THE RESERVES at EAGLE POINT

445 NORTH PICADILLY RD - BUILDING H

AURORA, **22-3219** **COLORADO**

APARTMENT BUILDING H
UNDER FLOOR WASTE AND VENT PLAN

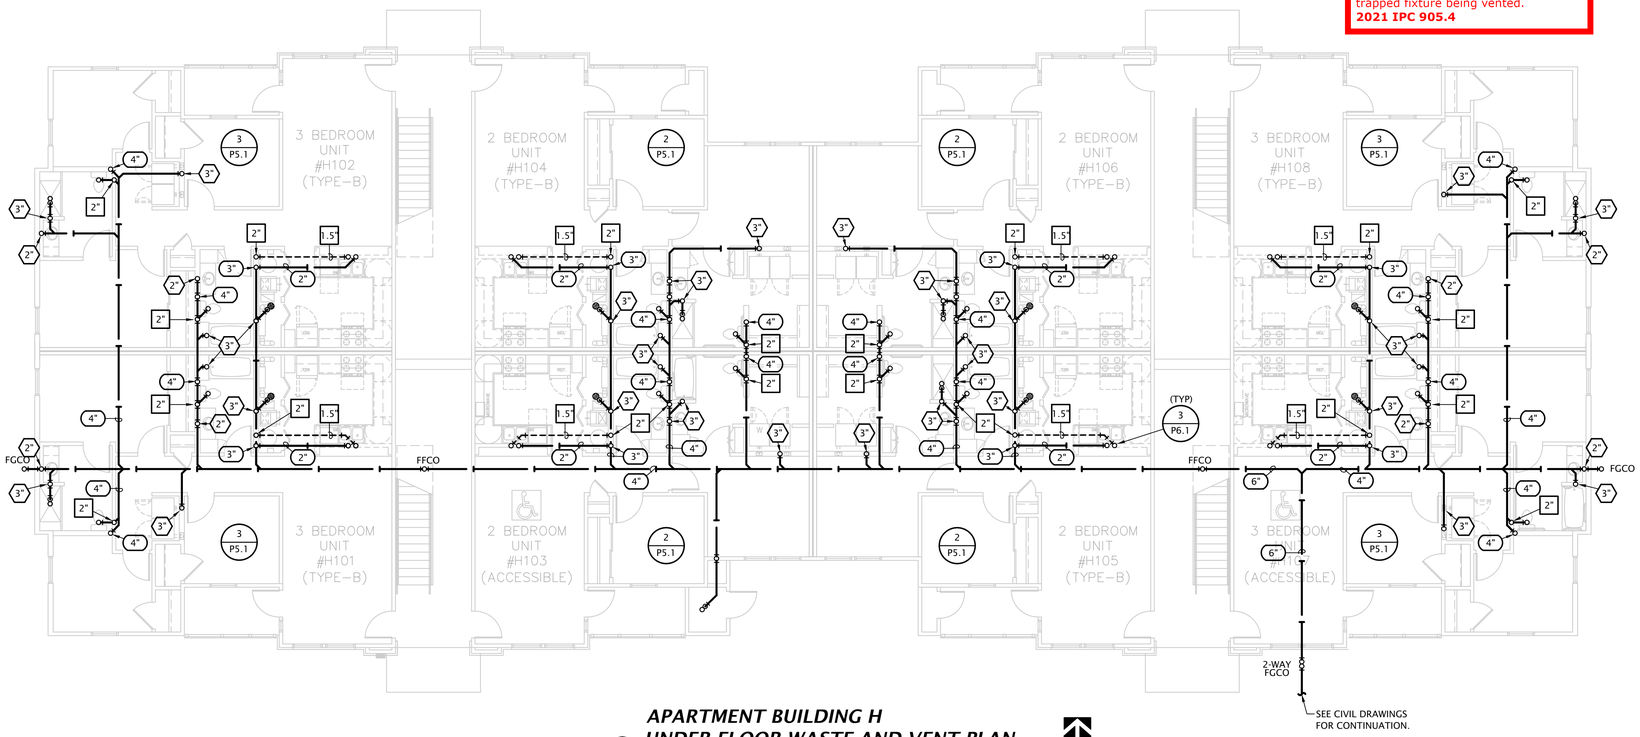
The dry vent must rise 6" vertically above the flood level rim of the highest trapped fixture being vented. **2021 IPC 905.4**

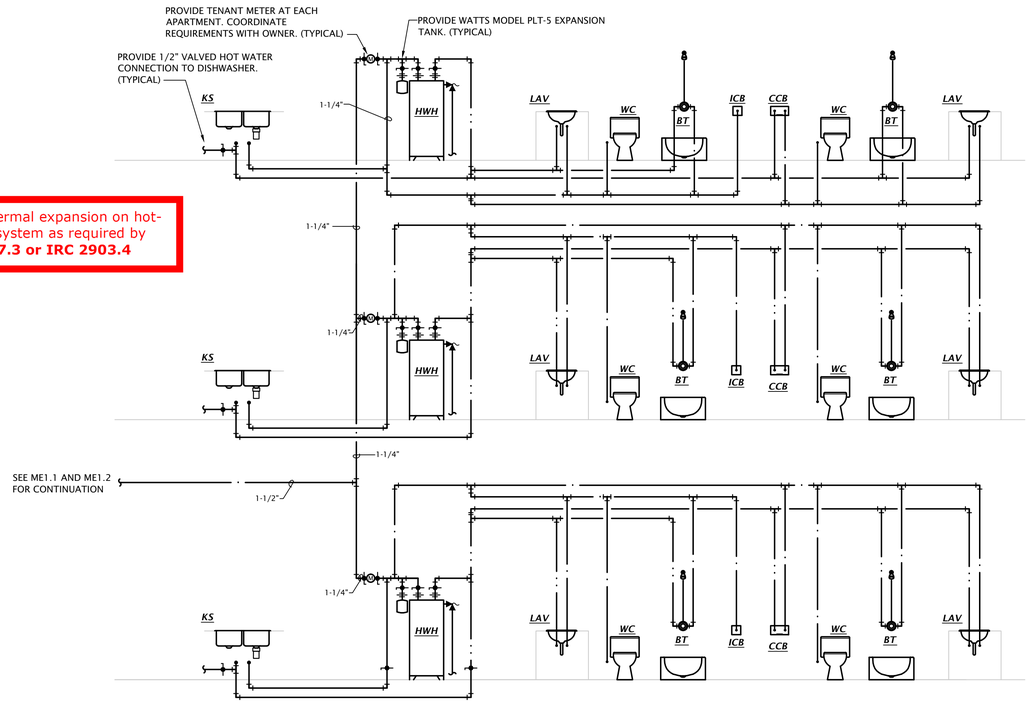
Provide for thermal expansion on hot-water supply system as required by **2021 IPC 607.3 or IRC 2903.4**
